CITY OF RIVERSIDE, CALIFORNIA
DEPARTMENT OF PUBLIC WORKS
SEWER PLAN & PROFILE
GRAND AVENUE
TRACT 2203
HORIZ. SCALE 1"=40' VERT. SCALE 1"=4'
APPROVED BY: *J. F. Davidson* Director of Public Works
NO. **S-285**
DATE 4-2-61 SHEET 1 of 2

J. F. DAVIDSON, CIVIL ENGINEER
 APPROVED BY *J. J. Davidson* 3/6/61
 CITY OF RIVERSIDE, CALIFORNIA
 DEPARTMENT OF PUBLIC WORKS
 SEWER PLAN & EASEMENT
 OLD RANCH ROAD
 AND EASEMENT
 TRACT 2203
 SCALE 1" = 40'
 S-285
 2 2
 4-12-61
 L.S.W.
 for William D. Gardner

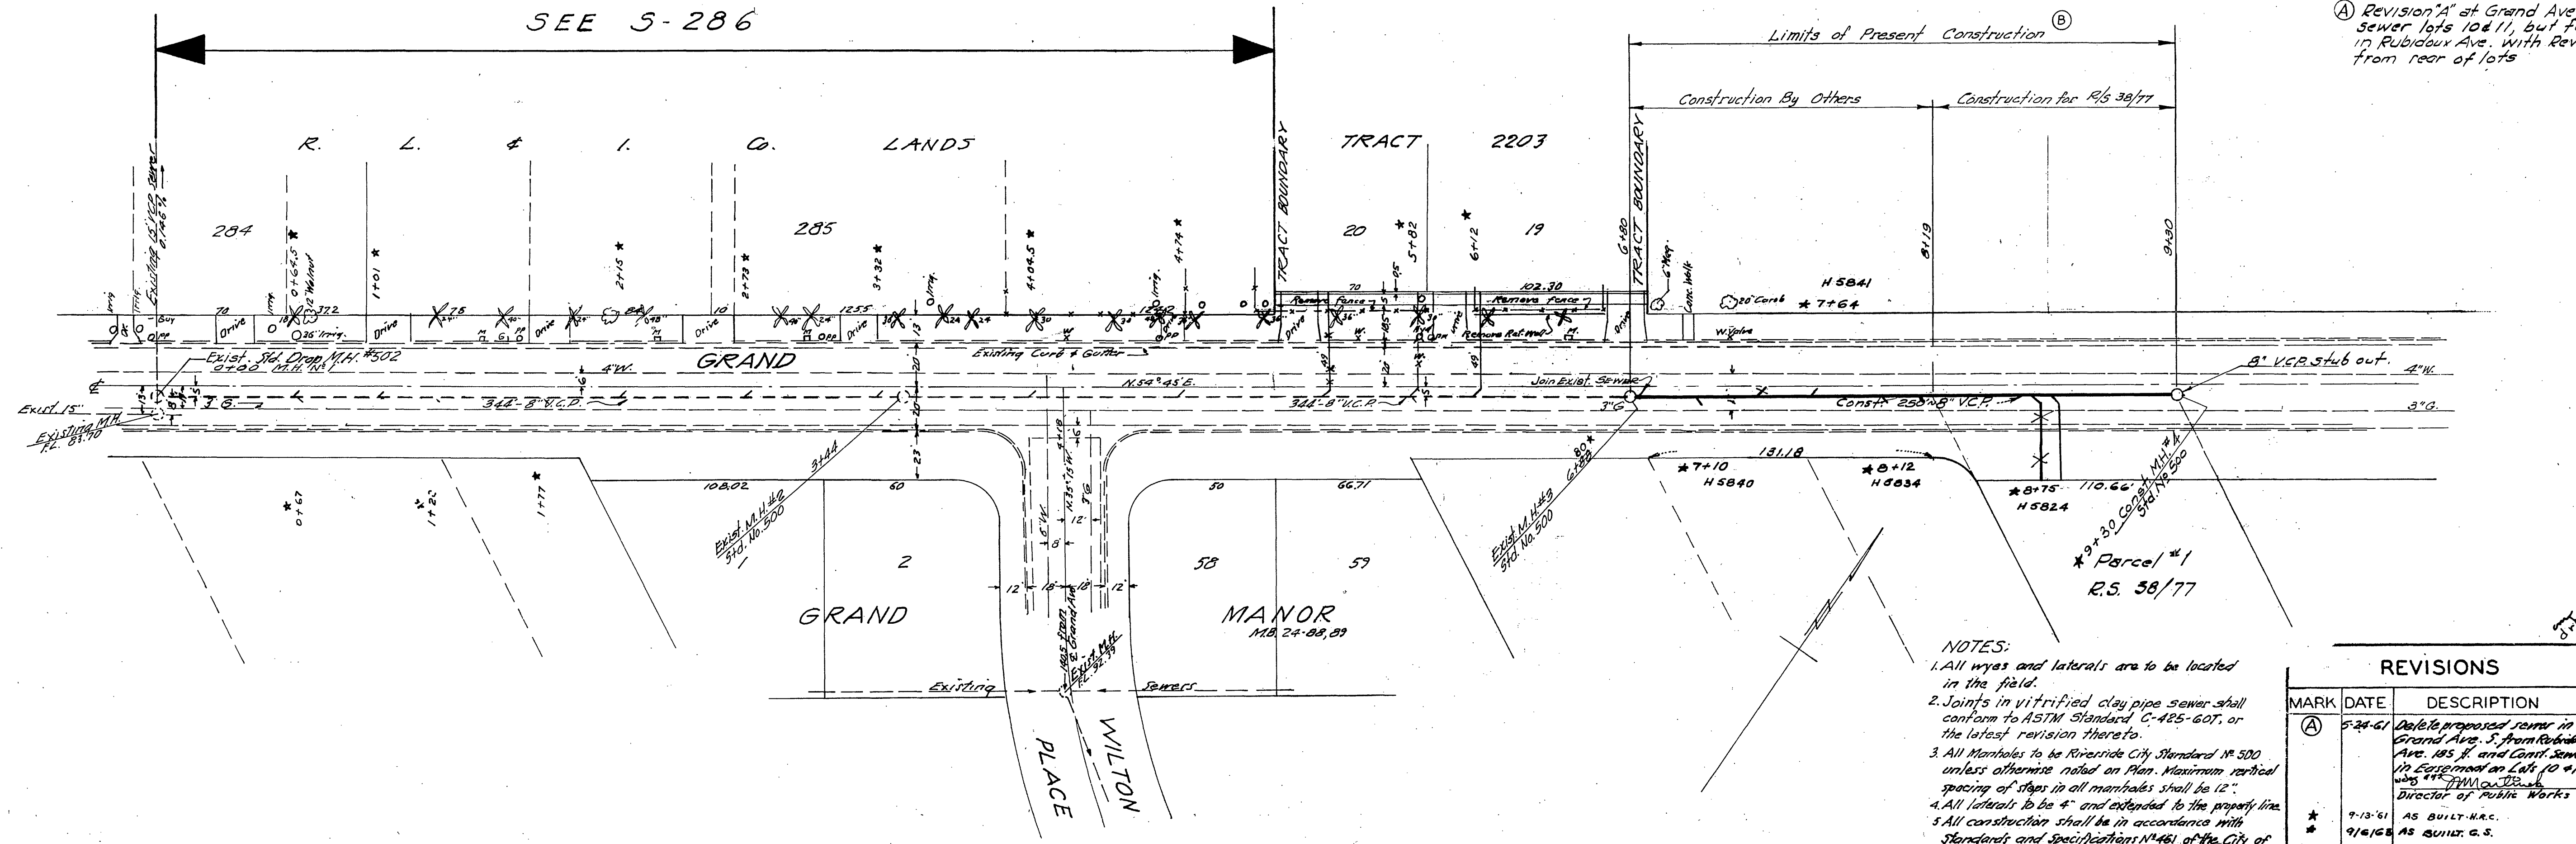
Ⓐ Revision "A" at Grand Ave and Rubidoux Ave. was proposal to sewer lots 10 & 11, but found impossible because of storm drain in Rubidoux Ave. with Revision "A" lots 10 & 11 were sewer from rear of lots

REVISIONS		
MARK	DATE	DESCRIPTION
Ⓐ	5-24-61	Delete proposed sewer in Grand Ave. S. from Rubidoux Ave. 185 ft. and Cont. Sewer in Elevation on Lots 10 & 11 was 4" PVC 12' dia.
*	9-13-61	AS BUILT - H.R.C.
*	9/16/61	AS BUILT - C.S.

PROFILE ON SEWER EASEMENT

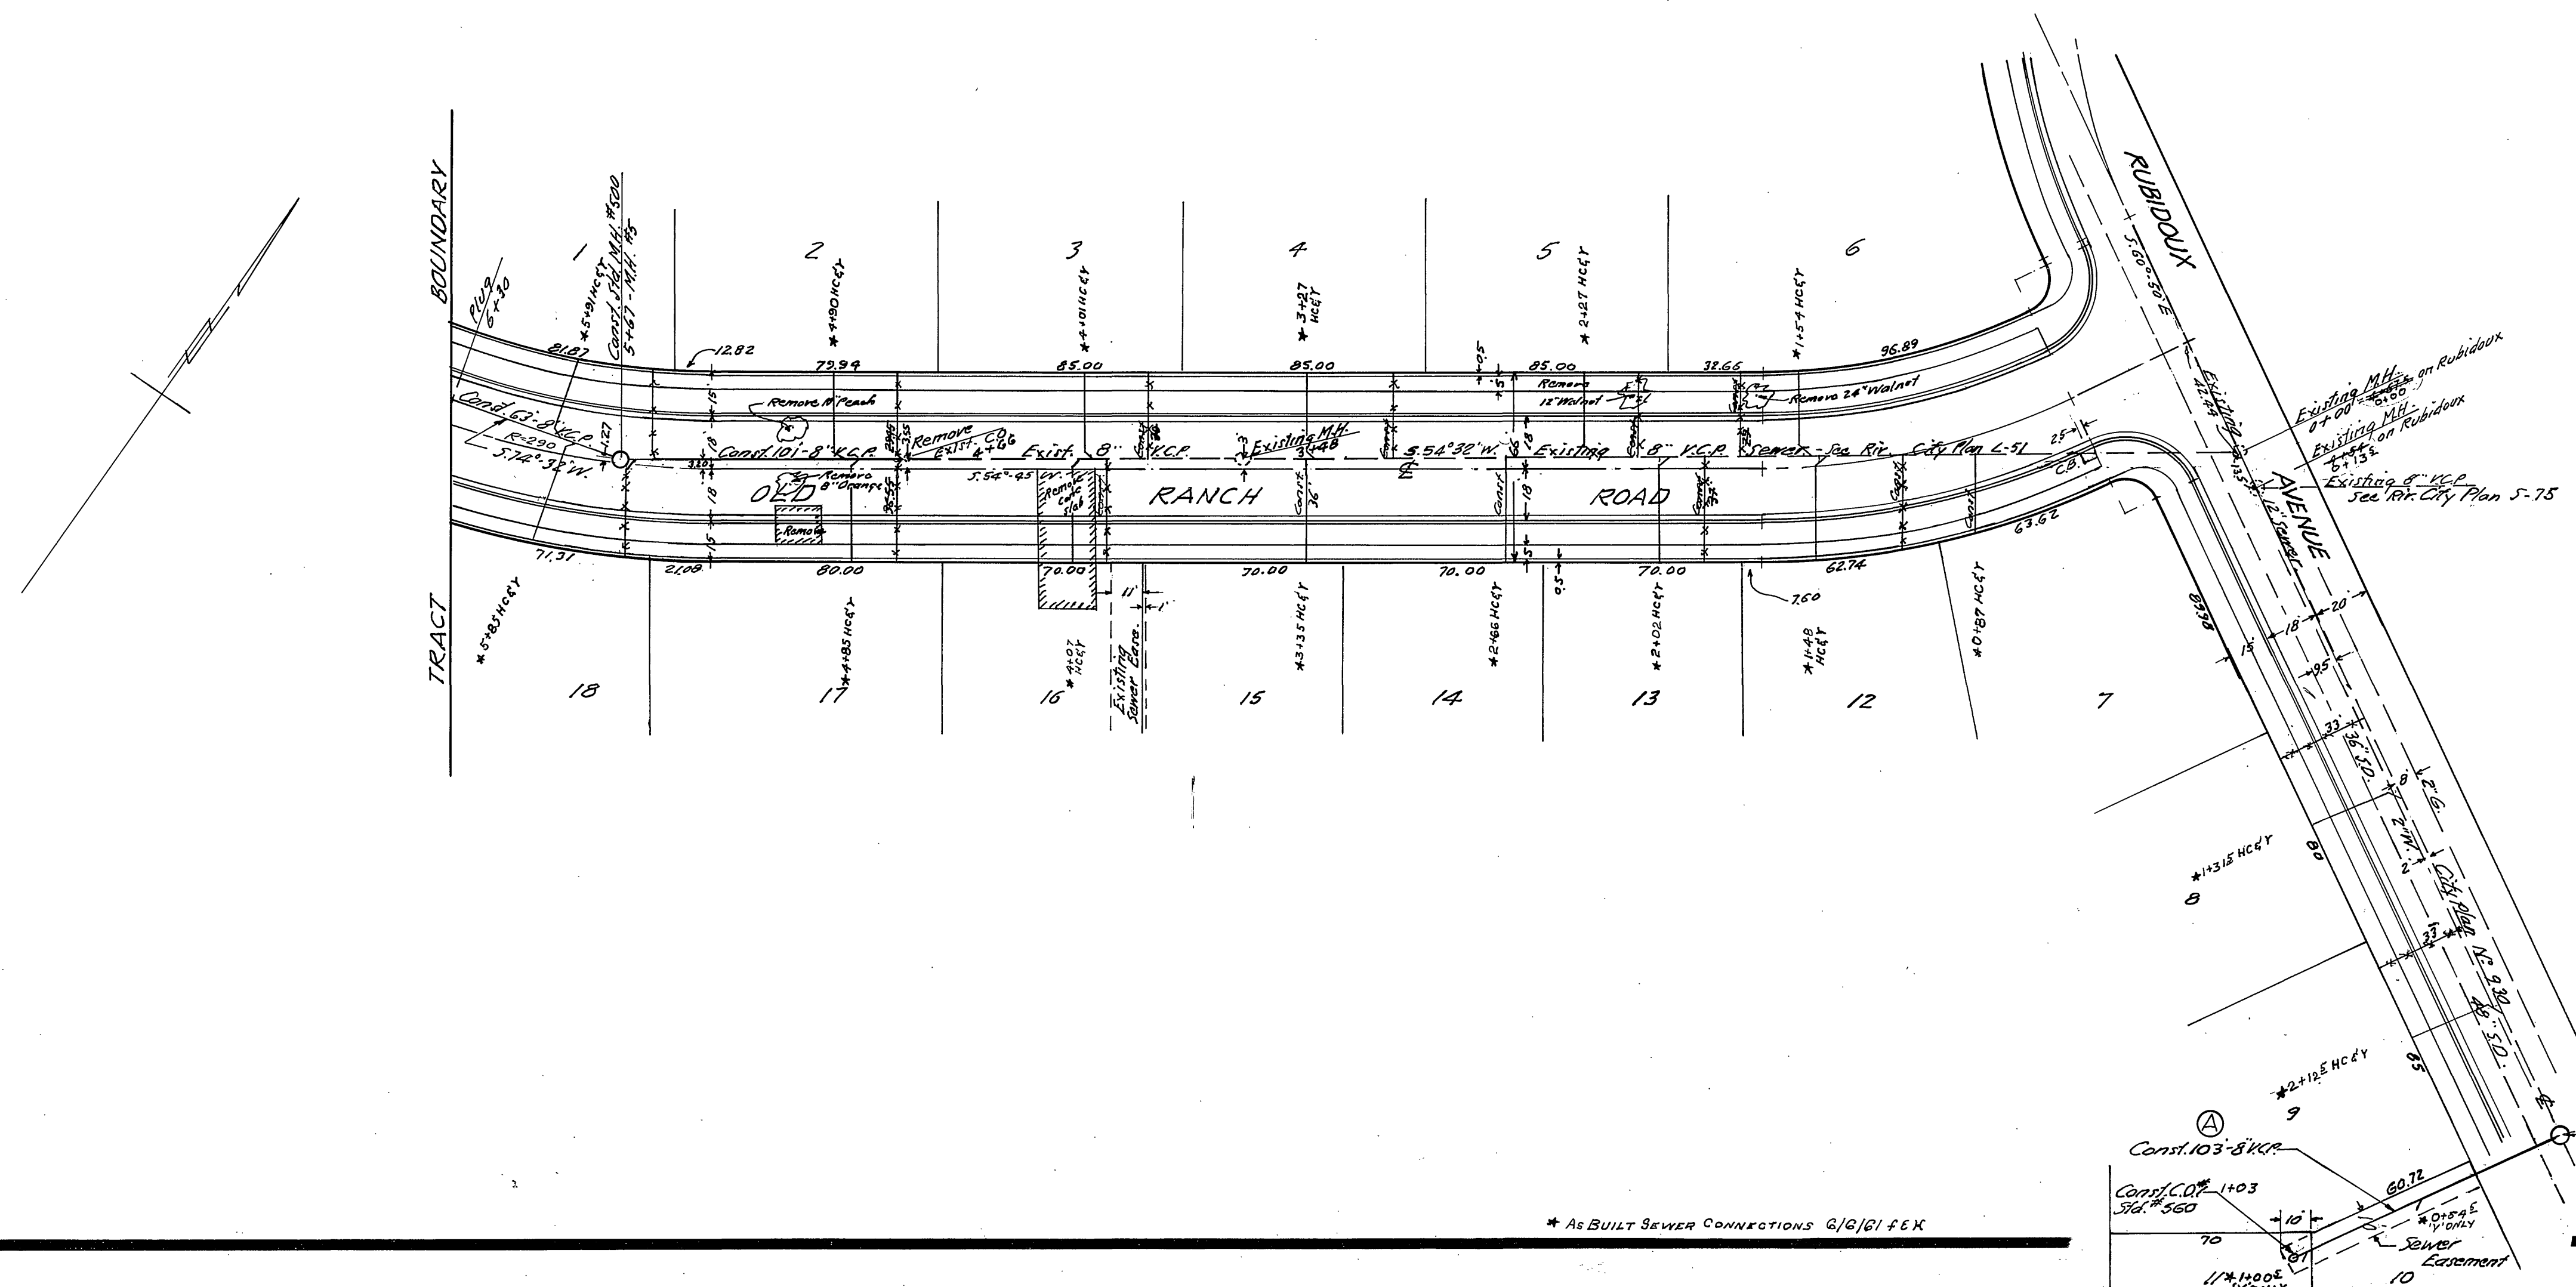
See Revised Elevations shown on forms in the field
